## Walkable Midtown: The Midtown-St. Albans Area Plan

Planning Commission  
Committee of the Whole  
Oct. 22, 2020

# Status Update

# Waterfront District: Urban Form (CP-2A-20)

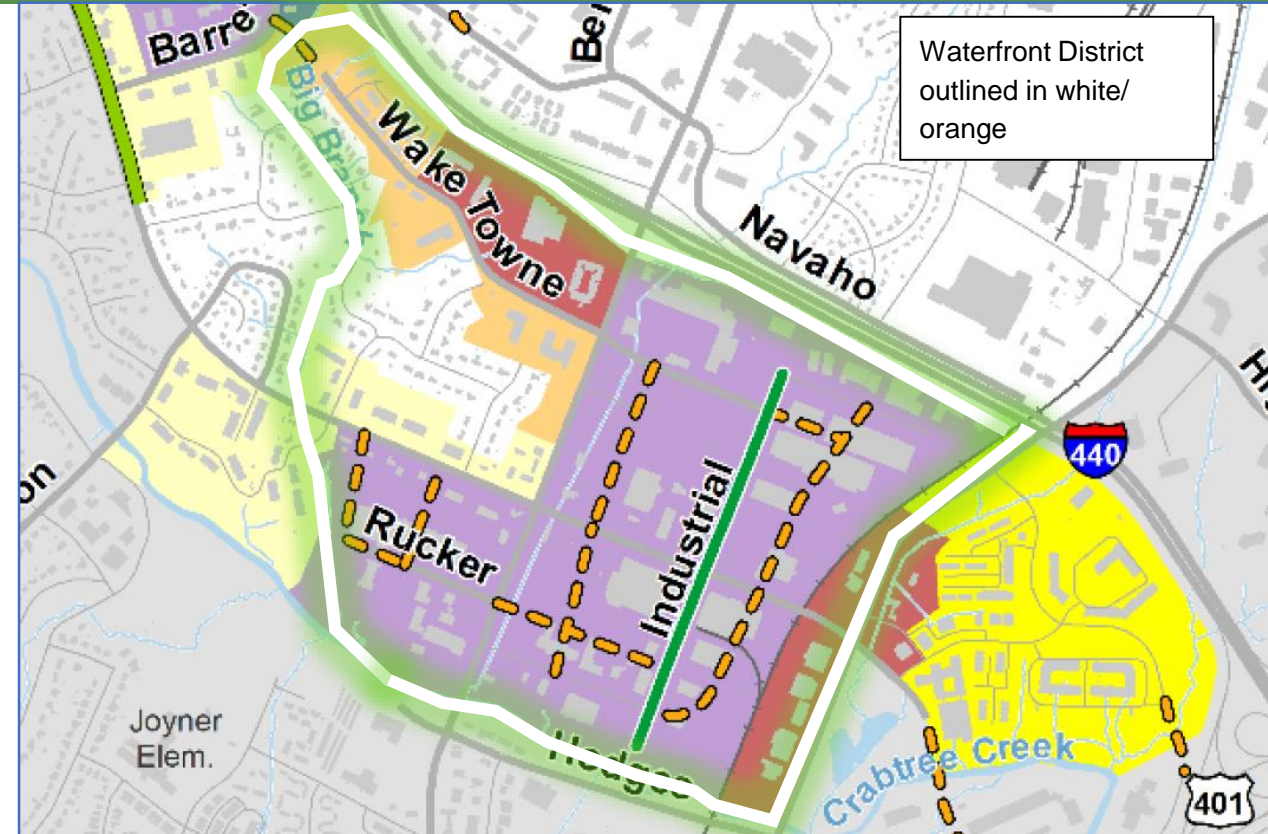
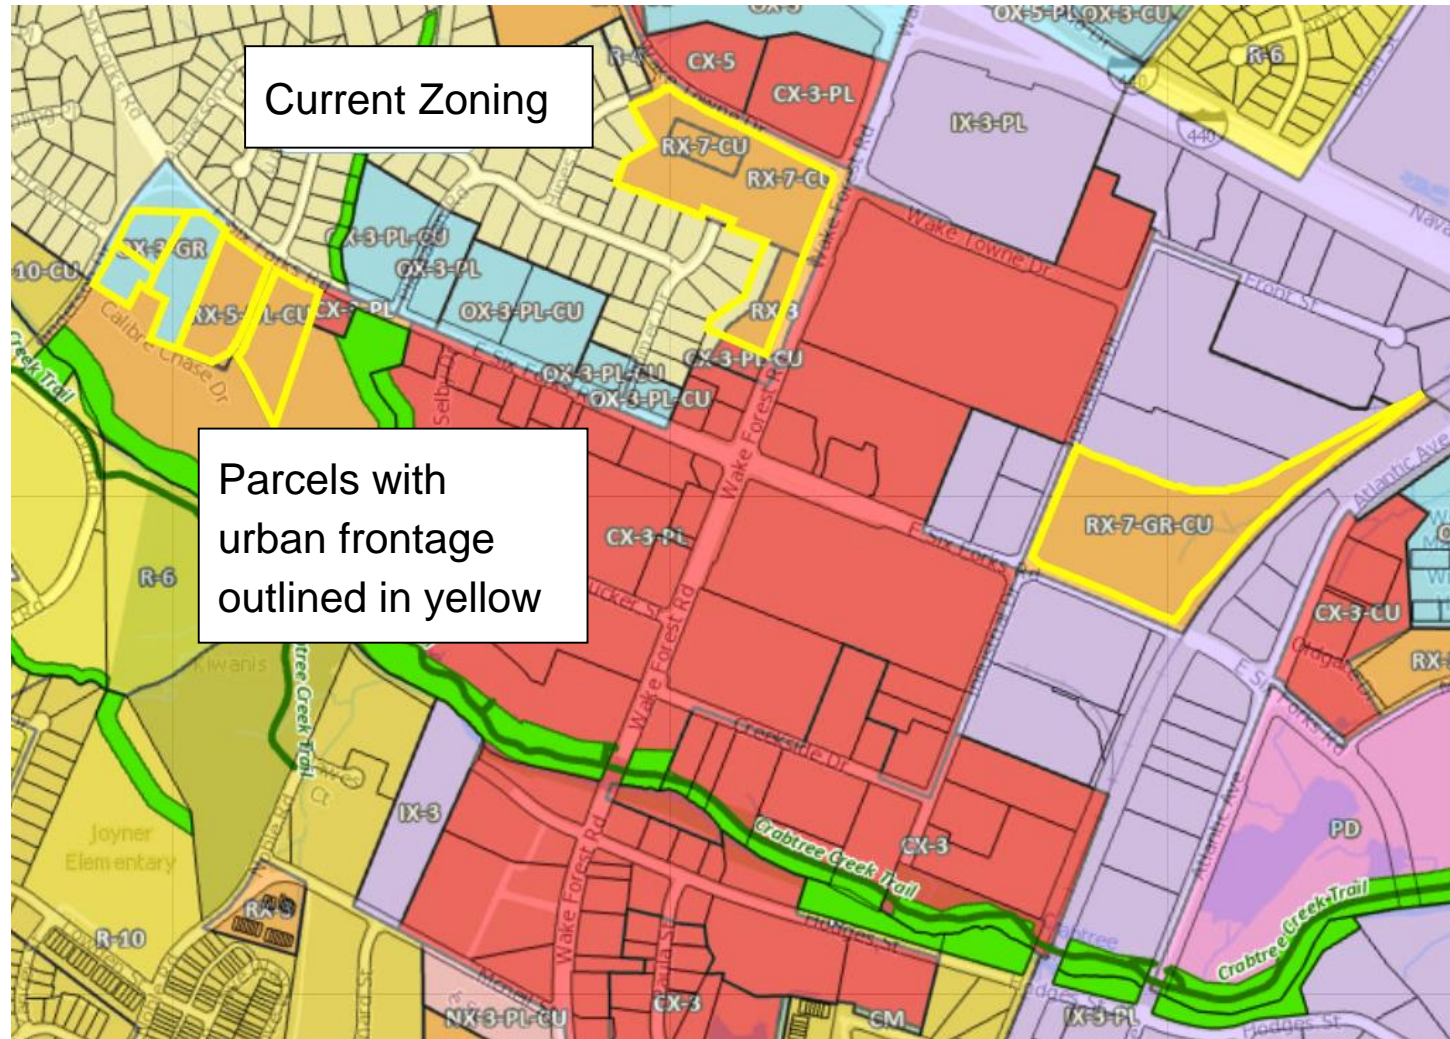
**Comment:** Parking should be allowed between the building and street in the Waterfront District

1. Retain Plan recommendation of no parking between building and street (urban frontage). This reflects the plan principle of encouraging walkability.
2. Revise recommendation to reflect current policy, which allows some parking between building and street (hybrid frontage). This addresses the comment but does not align with plan principles supporting high levels of walkability.

# Waterfront District FLUM south of Six Forks (CP-2C-20)

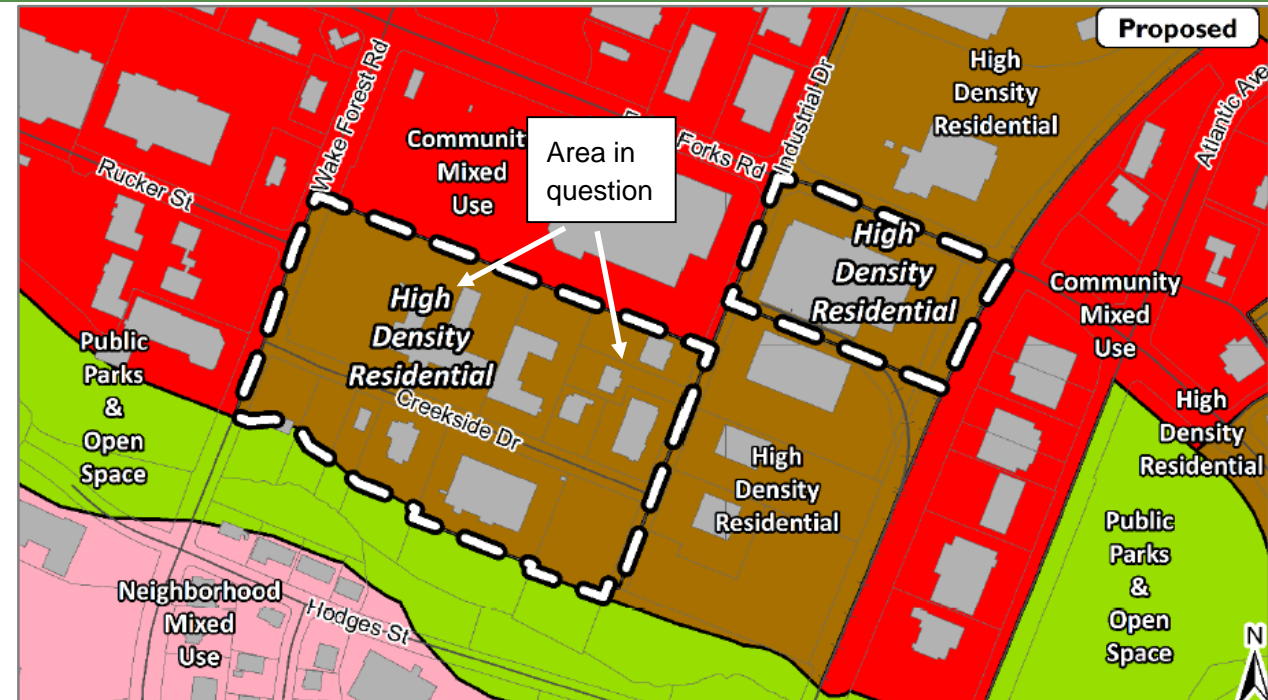
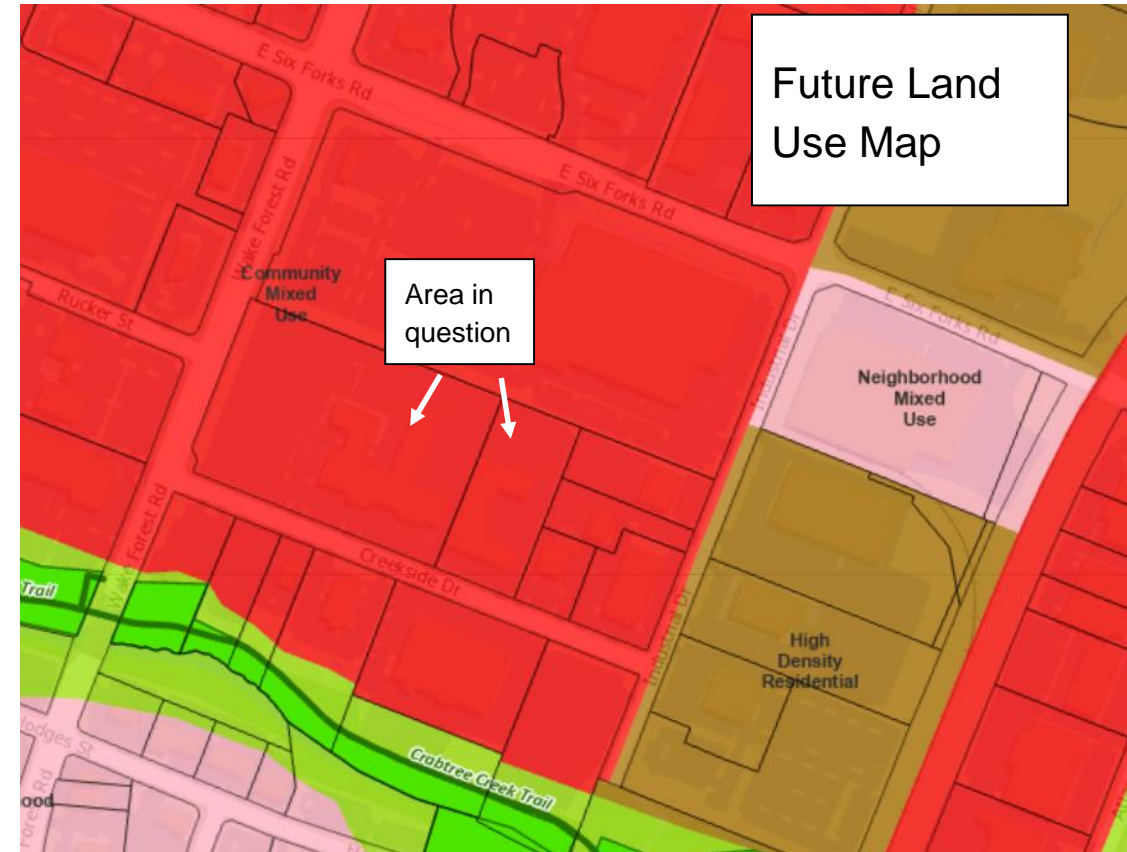
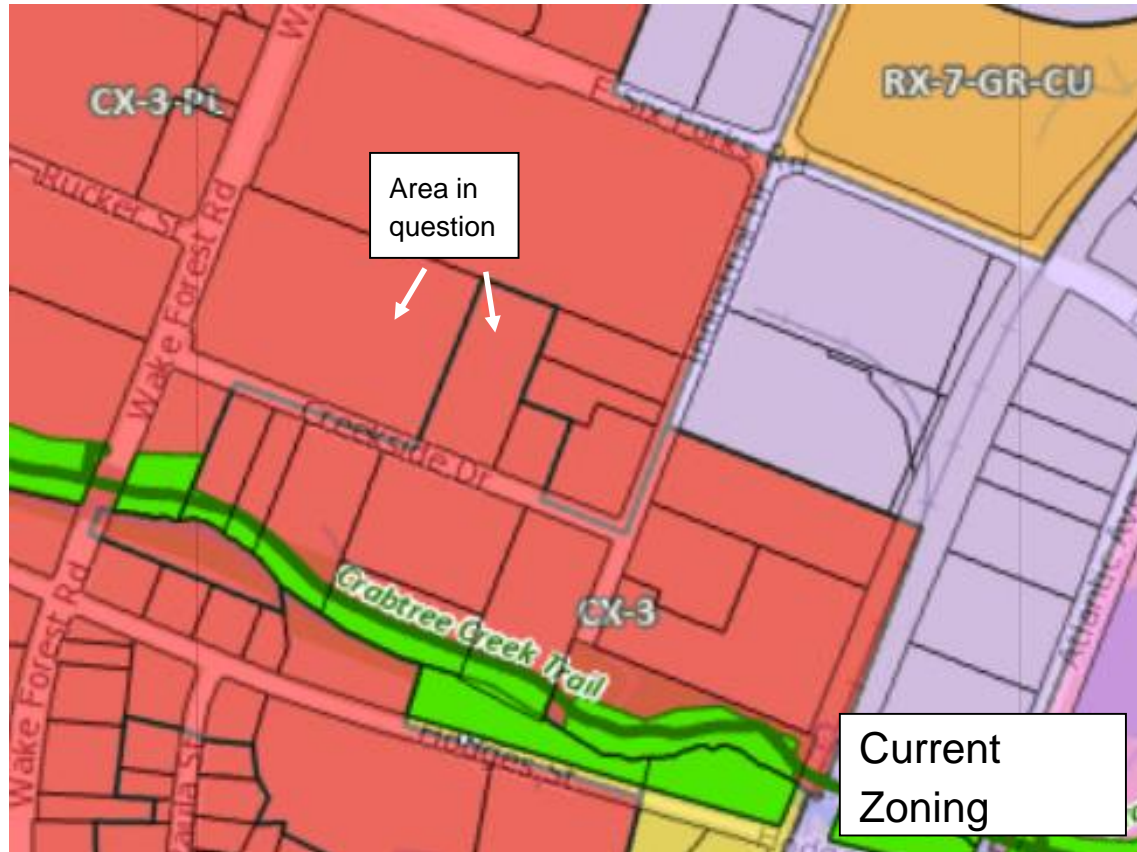
**Comment:** Leave Thompson properties (car dealership) as Community Mixed Use on FLUM. Plan recommends High Density Residential

1. Revise recommendation to retain existing Community Mixed Use designation. This addresses the comment and still aligns with the plan recommendation for the area.
2. Retain Plan recommendation of High Density Residential. This retains the plan emphasis on residential uses but does not address the comment.

# Waterfront District: Street Plan south of Six Forks (CP-2D-20)

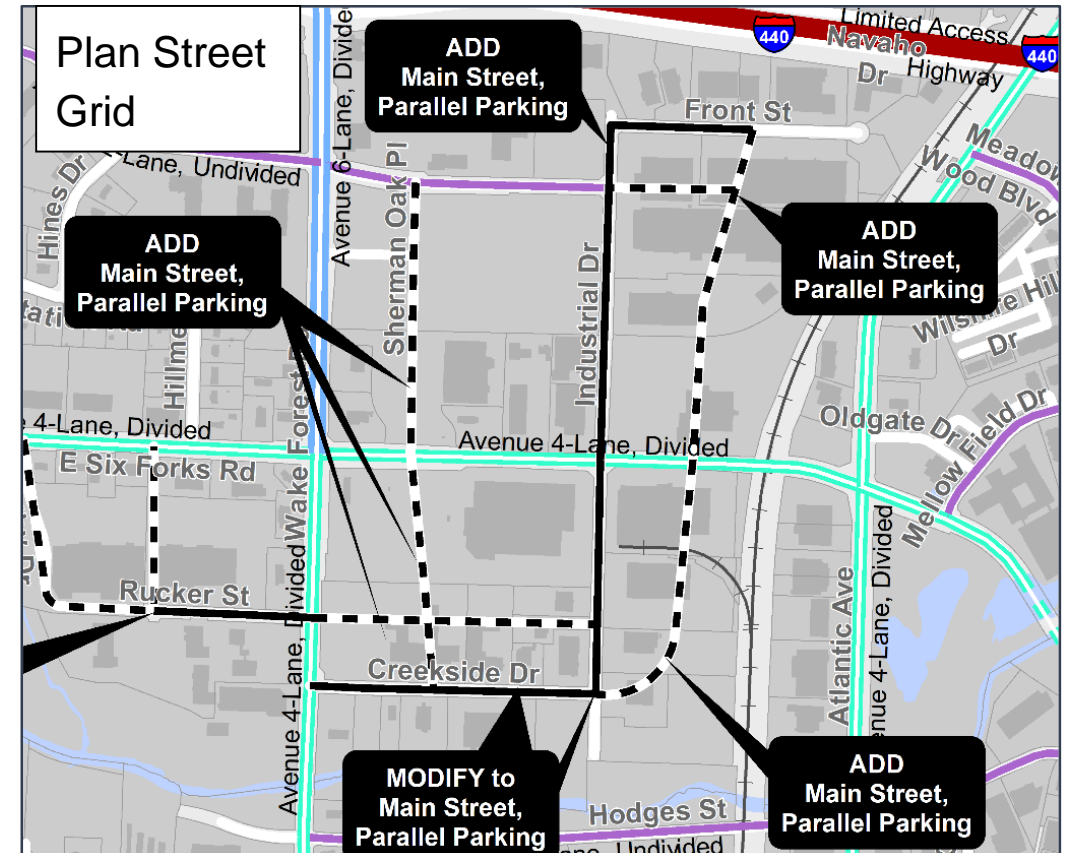
**Comment:** Eliminate new street crossing Thompson properties from Street Plan

1. Retain existing proposal. This aligns with the plan recommendation for walkability in this area, which is enhanced by adding to the street density.
2. Remove street from Street Plan. This addresses the comment but does not align with plan goals.

# Waterfront District: FLUM at north end of Industrial (not currently part of CP-2-20)

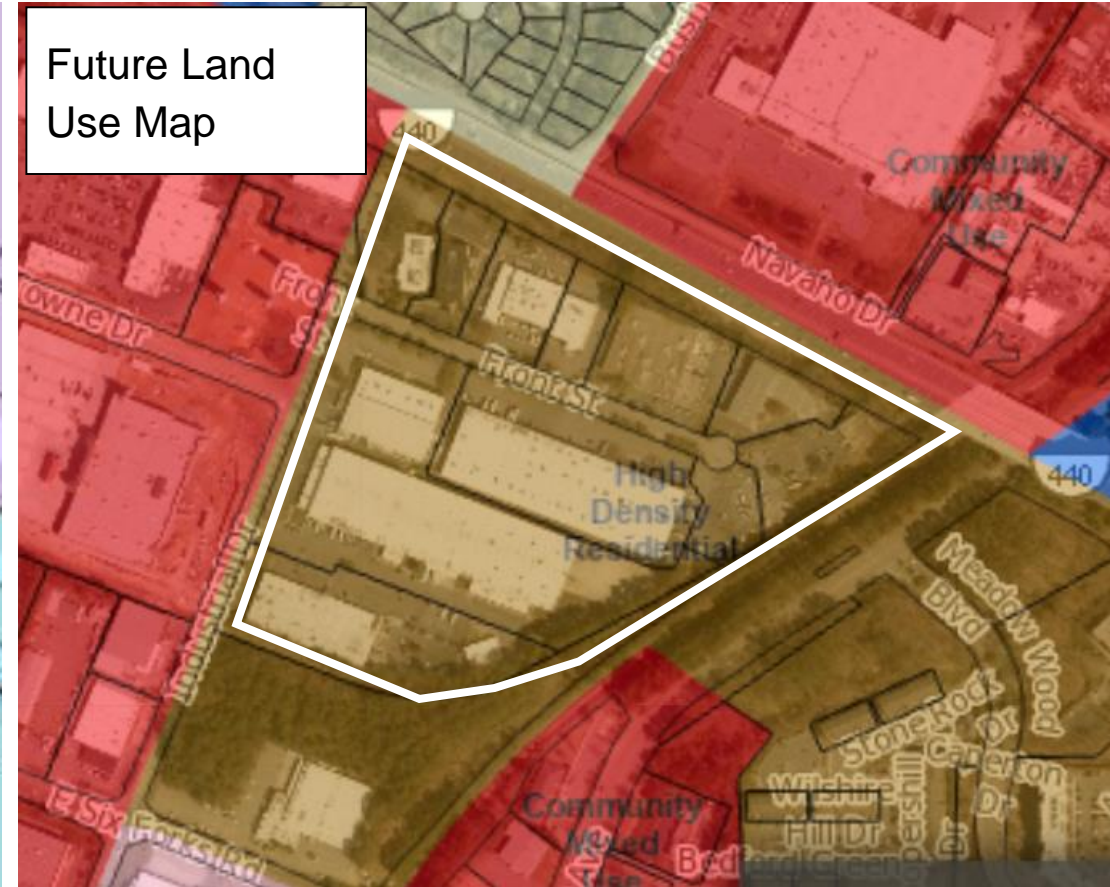
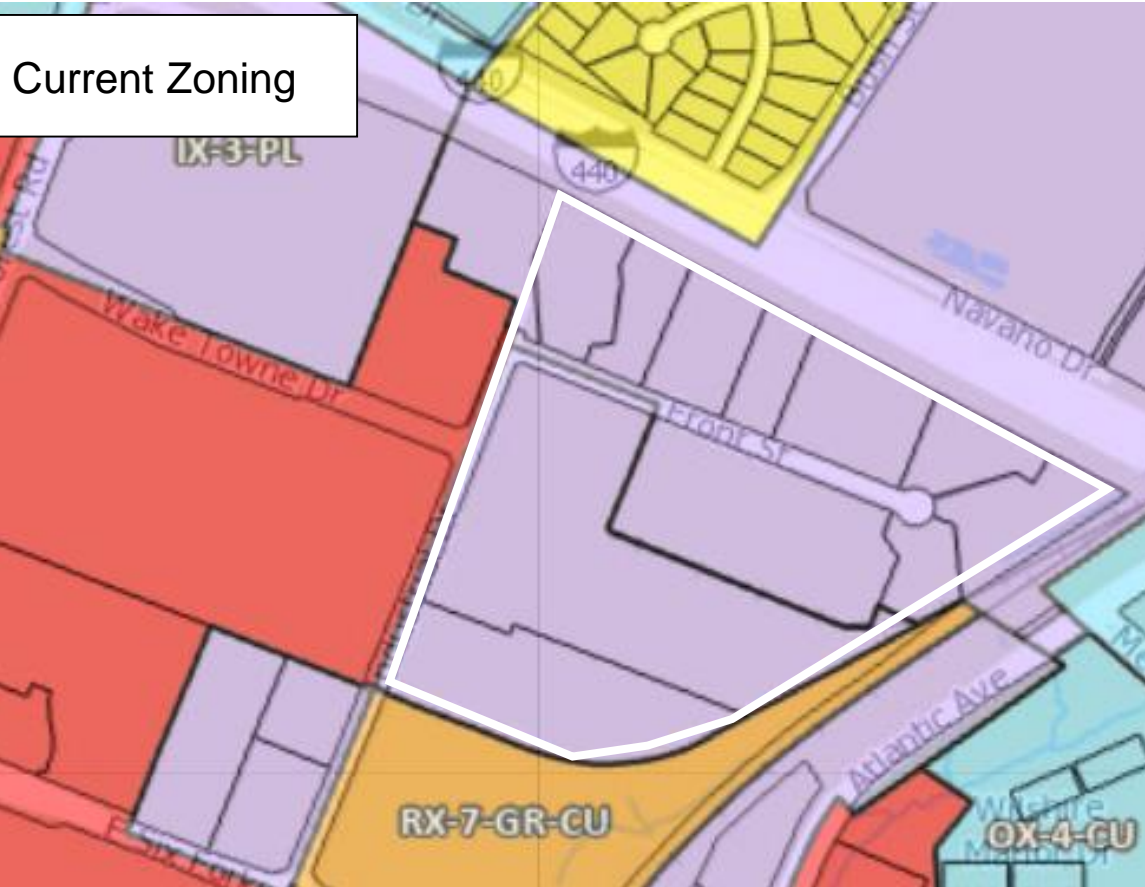
**Comment:** Commercial Mixed Use is an appropriate designation for Industrial/Front street properties

1. Create a recommendation to revise to Community Mixed Use designation, which does reflect existing zoning. This addresses the comment and aligns with plan recommendations for a mix of uses in the area.
2. Retain current designation of High Density Residential along with the plan's added guidance that office uses. This is very similar to the above recommendation but does not address the comment.
